NOTE TO: Sherwin E. Turk
Deputy Assistant Chief Hearing Counsel, OELD

FROM: John S. Ma, Structural Engineer
Structural and Geotechnical Engineering Branch
Division of Engineering, NRR

SUBJECT: COMMENTS ON THE APPLICANT'S RESPONSE TO STAFF AFFIDAVITS FILED
IN THE WATERFORD PROCEEDING

SUBJECT: Waterford 3 SES
Docket No. 50-382
Response to NRC Basemat Questions

Fig. 7.28. Typical mean shear stress-shear displacement relationships for aggregate interlock mechanism.^{7,11}

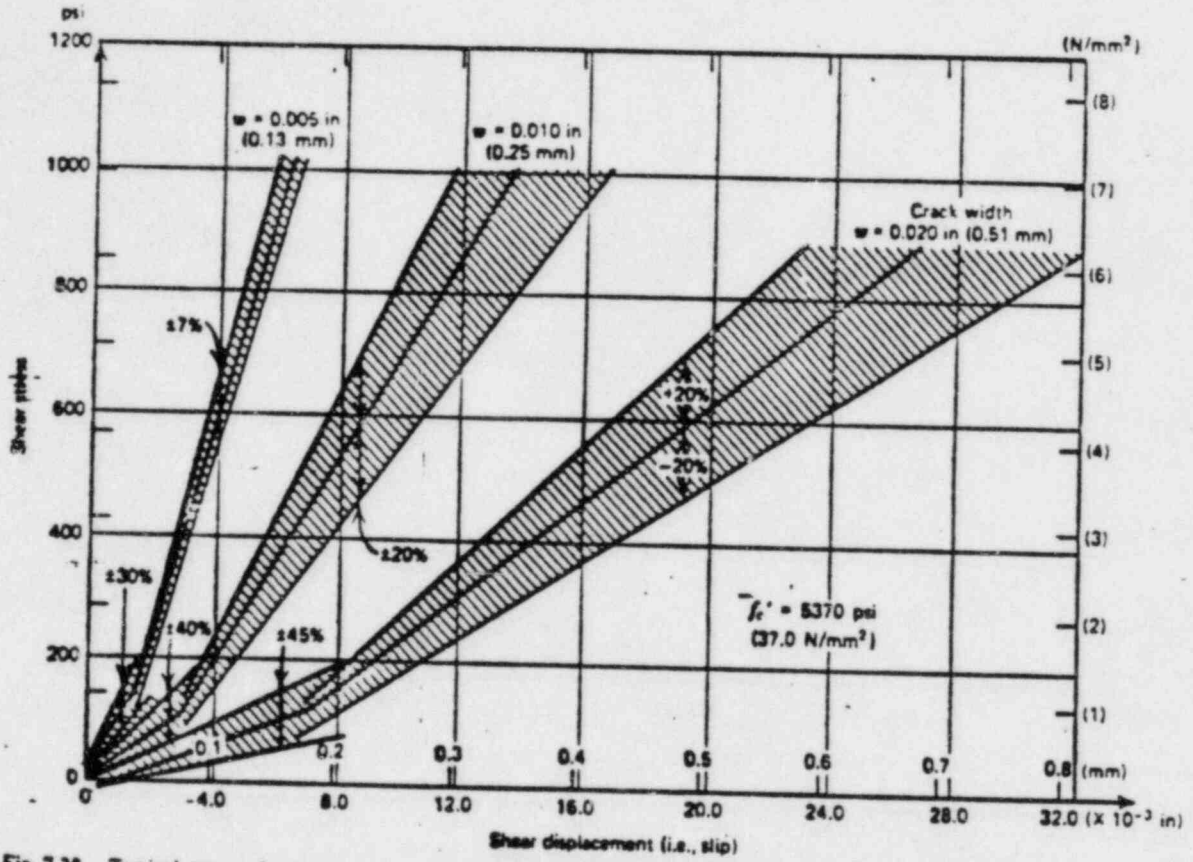
Laboratory testing results have indicated that the shear stiffness of a crack section is influenced by many factors, such as test methods, the amount of reinforcing steel across the crack surfaces and its distribution along the depth of the crack section, and size effect. Nevertheless, test data have confirmed that the crack width is the most important factor influencing the shear stiffness. The pictorial test data in Enclosure 1 present a good indication of the amount of reduction in shear stiffness versus crack widths with other factors being kept constant. The test data have also negated the Applicant's claim that "...there is [the crack's result] no change in the rigidity [stiffness] of the mat and no effect upon the dynamic response of the basemat to the earthquake." (Ehasz's affidavit, Attachment 1, page 23).
